10 **Matters arising in relation to “*The slip surface mechanism of delayed failure of the***
11 ***Brumadinho tailings dam in 2019*” by Fangyuan Zhu, Wangcheng Zhang & Alexander M.**
12 **Puzrin**

13 We are surprised by Zhu et al¹ (the Authors) concluding, based on numerical and analytical
14 modelling combined with previously published data, “*that the Brumadinho catastrophe can be*
15 *explained by the creep driven slip surface growth*”. This Discussion explains why such a
16 conclusion is not valid. We refer to the Author’s figures as ‘Fig 1’ with new figures as ‘Fig D1’ etc.

142 *Fig D 4 Externally measured displacements for tests on a stainless steel block tested on a triaxial cell using*
 143 *platens with lubricated ends. The stress condition was the same as in "Test 1" of the authors i.e $K_0 = 0.5$.*

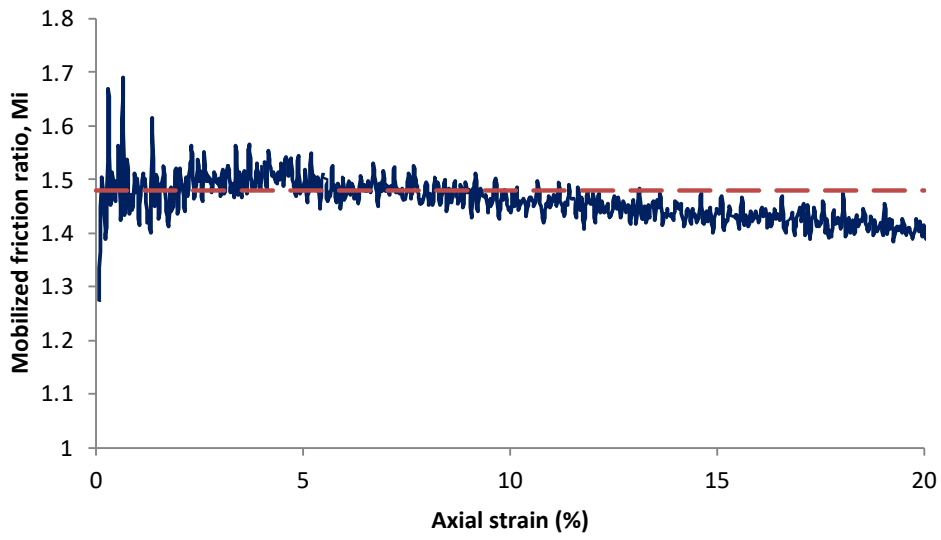
64 Furthermore, the “creep” observed in test TXDW03 is credibly just an artefact of the testing
65 procedure. We performed three triaxial tests on a stainless-steel block mimicking the conditions
66 of test TXDW03:

71 When lubricated platens and latex membranes were not used, the test on the steel block showed
72 no measurable displacements in time. Results for the other cases (Fig D3) suggest that a
73 significant proportion of the creep reported for TXDW03 was viscous deformation/compression of
74 the end lubrication (grease and membranes) rather than actual soil behaviour.

129 *Fig D 1 Mobilized friction on a drained triaxial test on loosely compacted ($e_0 = 1.1$) specimen of Brumadinho*

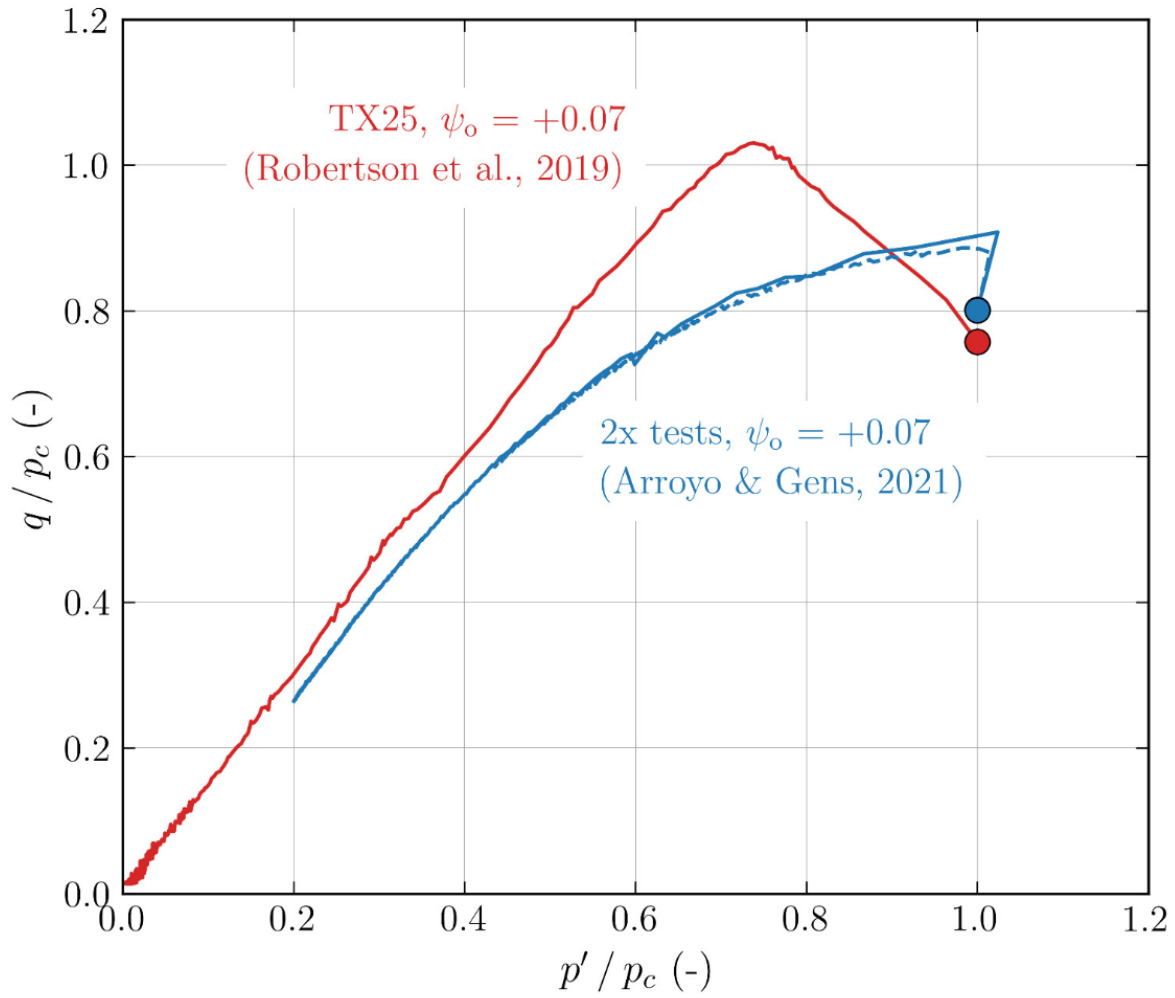
31 Bonding must be demonstrated by mechanical tests. The drained triaxial data in Fig 2b
32 corresponds to TX09 of Robertson et al., an initially dense specimen with shear localization
33 evident in the test report. The boundary-measured response in Fig 2b cannot be identified with a
34 material response. This is not generally the case for the more representative loose specimens,
35 which typically show a near constant critical friction ratio (M) with no rupture of a cohesion-like
36 component (Fig D 1).

133 **Fig D 2 Comparison of anisotropically consolidated undrained triaxial tests by Robertson et al. (2019) and**

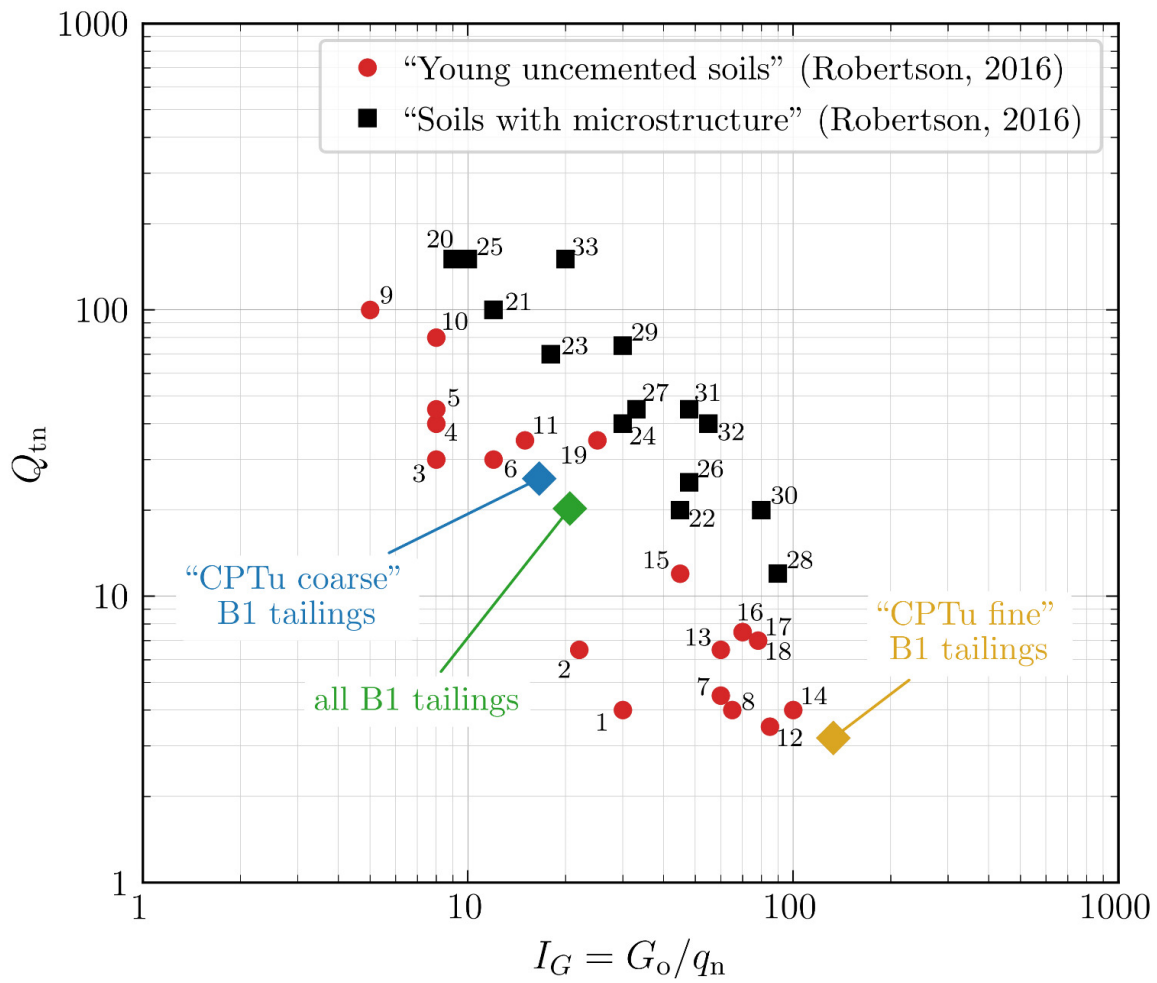
37 The undrained brittleness in Fig 2c is a consequence of void ratio, not bonding, and readily
38 computed by critical state theory. Reid et al.⁴ examined the effect of moist tamping preparation
39 procedures on subsequent undrained triaxial responses and found that much of the anomalously
40 brittle undrained behaviour noted by Robertson et al. was potentially caused by a too-dense
41 tamping process. This is illustrated in Fig D 2 which compares two specimens of B1 tailings
42 sheared undrained from the same initial state parameter. The specimens tested by Robertson et
43 al² – tamped initially into a denser state – show peaks that are not present in the specimens of
44 Viana da Fonseca et al.⁵, which were tamped loose.
